1 ADDENDUM #2

Project Title:
Montague Consolidated School

MONTAGUE
CONSOLIDATED
SCHOOL

1 LOWER LEVEL DEMOLITION PLAN - PARTIAL **O**
 ASK-201 1 : 100

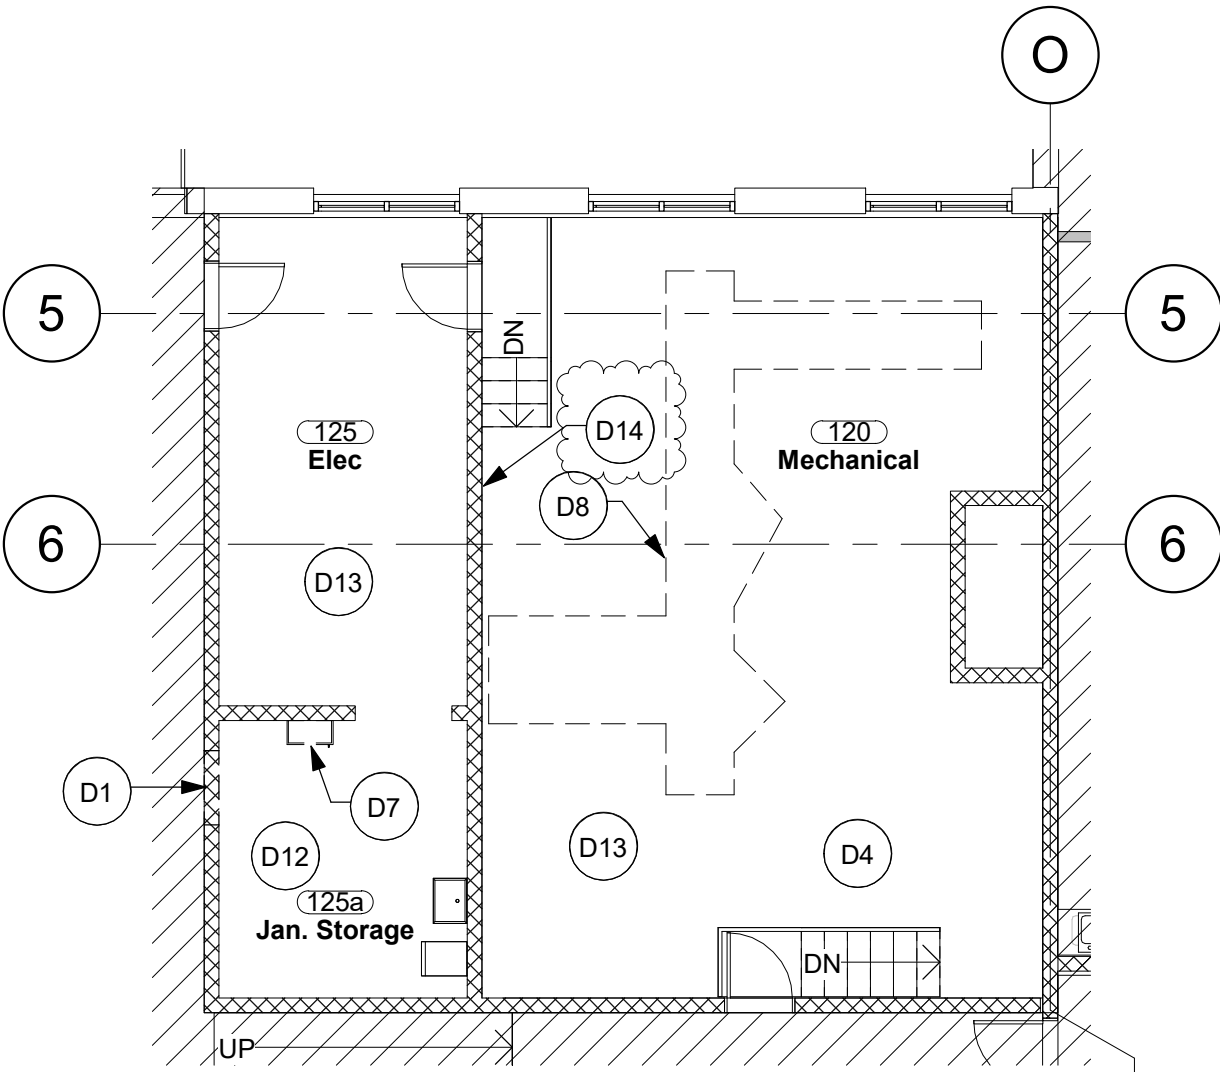
- .2 CLARIFICATION:
After removal of existing panelboard 'G', provide for remediation and reinstatement of existing west concrete block wall. Refer to Architectural Sketch ASK-201 attached and forming part of this addendum, for additional information.

CONTRACT #2 DEMO NOTES	
D8	SAW CUT EXISTING CONCRETE FLOOR. REFER TO MECHANICAL DRAWINGS M2-100.
D9	REMOVE FLOORING MATERIAL (HAZARDOUS MATERIAL)
D10	REMOVE TOILET
D11	REMOVE SINK
D12	EXISTING TERRAZZO FLOOR TO REMAIN
D13	EXISTING FLOOR FINISH TO REMAIN
D14	EXISTING PANELBOARD 'G' TO BE REMOVED. PROVIDE FOR REINSTATEMENT AND REMEDIATION OF EXISTING CONCRETE BLOCK WALL,

Project Number:
201104
Drawing Number:
ESK-201

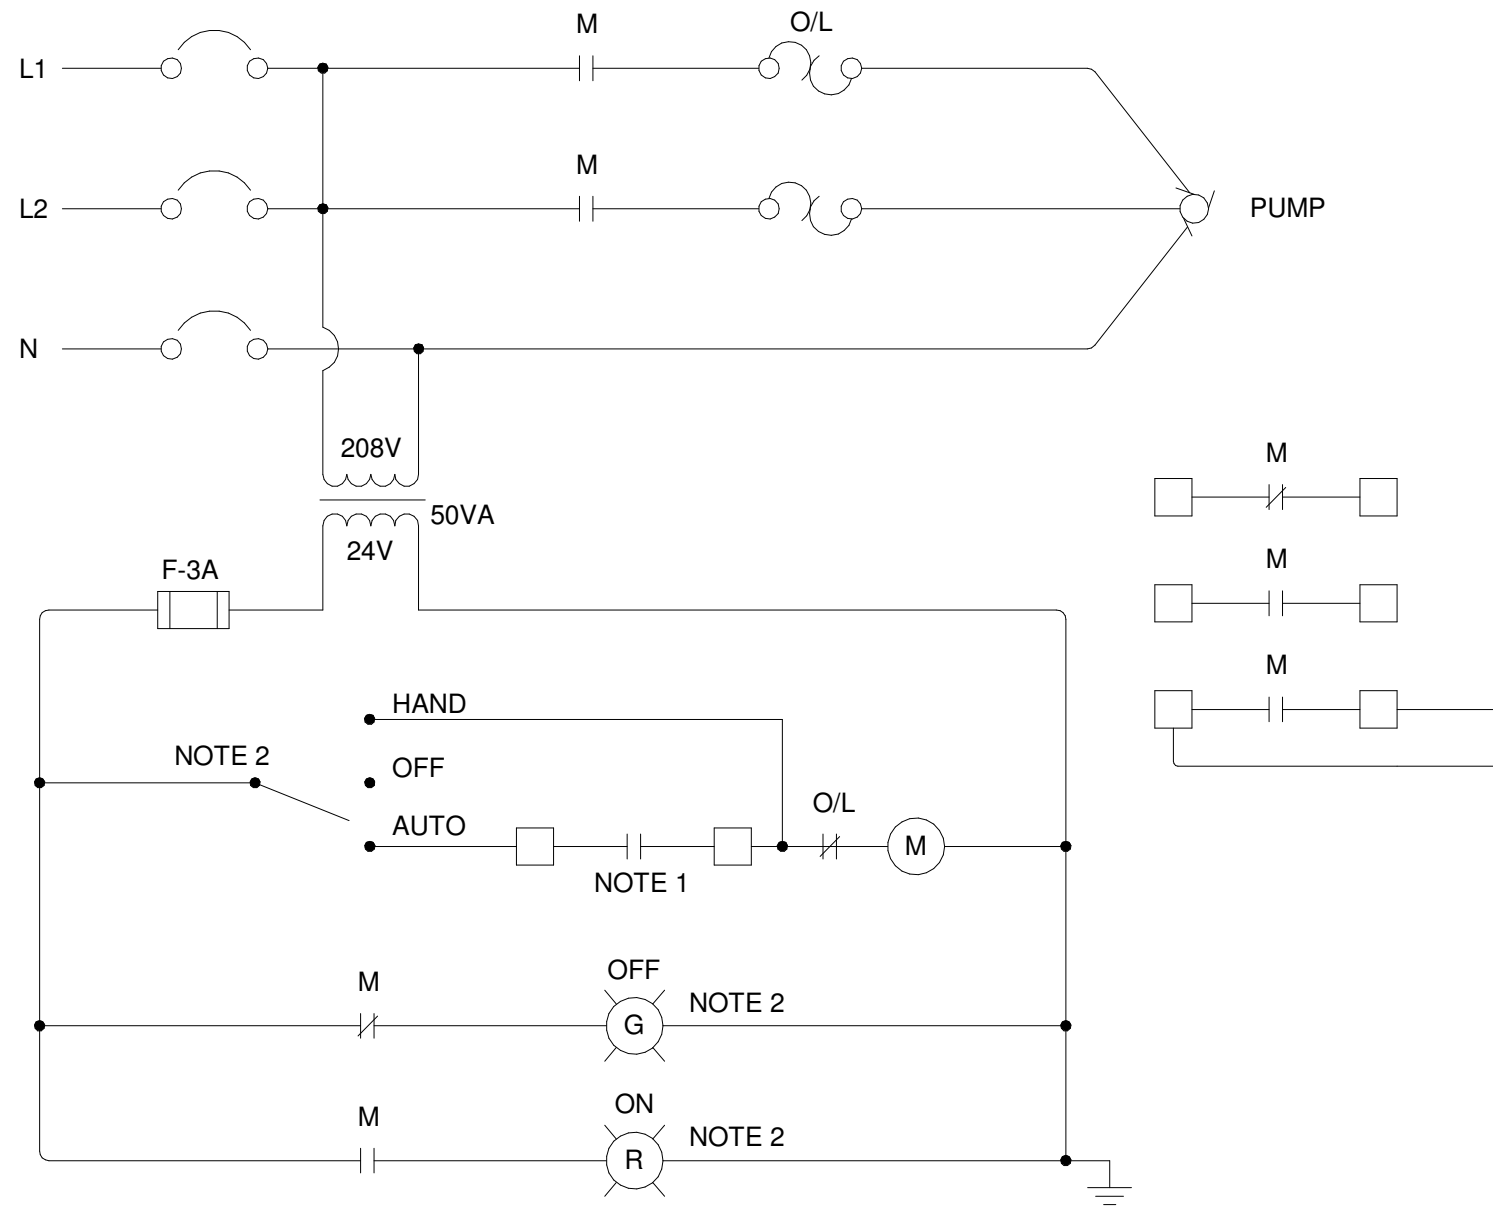
- .1 Reference Detail 3/E2-100:
 - .1 Delete Detail 3 in its entirety and replace with Sketch ESK-201, attached and forming part of this addendum.
- .4 Reference Drawing E2-200 - Lower & Upper Level Demolition Plan - Power:

TWO (2) EXISTING SERVICE MASTS TO BE DISCONNECTED AND REMOVED BY MECL. ELECTRICAL CONTRACTOR TO CUT AND CAP EXISTING 4" C SURFACE MOUNTED TO EXTERIOR FACADE OF BUILDING UNDERGROUND OUTSIDE BUILDING FOUNDATION AND REMOVE SURFACE MOUNTED CONDUIT. UNDERGROUND INCOMING SERVICE FEEDERS ASSOCIATED WITH EXISTING 600A, 120/208V, THREE PHASE, FOUR WIRE SWITCHBOARD TO BE DISCONNECTED AND REMOVED

SURFACE MOUNT 27mmC TO EXTERIOR FACADE OF BUILDING AND THEN PENETRATE INTO ACCESSIBLE CEILING SPACE OF ELECTRICAL ROOM 125. SECURELY FASTEN EXPOSED 27mmC TO EXTERIOR FACADE OF BUILDING WITH PVC STRAPPING AND STAINLESS STEEL FASTENERS. SEAL AROUND EXTERIOR PENETRATIONS WITH LOW VOC MASTIC COMPOUND. PROVIDE CONDUIT WITH WEATHERPROOF EXPANSION SLEEVES SUITABLE FOR LINEAR EXPANSION

CONTRACTOR TO EXCAVATE AS REQUIRED TO INSTALL TWO (2) NEW 103mm UNDERGROUND CONDUITS. TWO (2) 103mm UNDERGROUND CONDUITS TO BE ROUTED UPWARDS SURFACE MOUNTED TO EXTERIOR FACADE OF ELECTRICAL ROOM 125 AND THEN PENETRATE WITH AN LB ELBOW INTO ACCESSIBLE CEILING SPACE OF ELECTRICAL ROOM 125 AND THEN DOWNWARDS TO FEED NEW 600A, 120/208V, THREE PHASE, FOUR WIRE SERVICE RATED DISCONNECT SWITCH. TWO (2) 103MM EXPOSED CONDUITS TO BE EXPOXY RIGID CONDUITS. SECURELY FASTEN EXPOSED 103mmC TO EXTERIOR FACADE OF BUILDING WITH PVC STRAPPING AND STAINLESS STEEL FASTENERS. SEAL AROUND EXTERIOR PENETRATIONS WITH LOW VOC MASTIC COMPOUND. PROVIDE CONDUIT WITH WEATHERPROOF EXPANSION SLEEVES SUITABLE FOR LINEAR EXPANSION

CONNECT 1#1/0 BARE GROUND CONDUCTOR FROM SERVICE GROUND BUS TO TWO 10'-0" LONG MANUFACTURED GROUND RODS DRIVEN INTO THE GROUND IN GRASSED AREA 3'-6" FROM THE BUILDING FOUNDATION AND SEPARATED 10'-0" APART IN ACCORDANCE WITH CSA 22.1-18 SECTION 10.
